ADDENDUM TO ENGINEERING GEOLOGICAL INVESTIGATION

AALWYNDAL HOUSING DEVELOPMENT ERF 21244 - MOSSEL BAY

Title:	Addendum to Aalwyndal Housing Development – Erf 21244
Project No:	GT-19-104- Addendum

Subject: Addendum to the Engineering Geological Report - Aalwyndal Housing

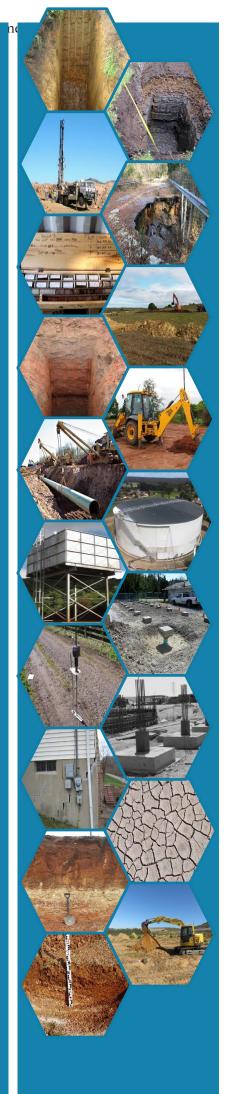
These specialist studies have clearly defined the extent of the flood lines and marshy areas, proving that the inferred non-perennial stream indicated on Figure 6 of the Geotechnical report, does not intersect the site as previously indicated and as such the **investigated site does not pose any risk of being exposed to elevated volumes of surface water runoff, that could lead to localized flooding**. There is however a localized depression in the north western corner, that could lead to ponding of surface water.

Due to these specialist studies, changes to the zoning of the site (specifically Zone D) will occur. The following changes are deemed to more accurately define the on-site conditions and should be accepted as correct.

The major change that these findings bring to the geotechnical report is the shifting of the indicated non-perennial drainage feature. Through the evidence provided it can now be assumed that this drainage does not intersect or have any influence on the investigated area. The minor depression in the north western corner will lead to ponding of surface water during high rainfall. Surface drainage measures needs to be implemented as described in the original report.

Please refer to the updated table 5 and Figure 6 below, for the updated geotechnical zoning of the site.
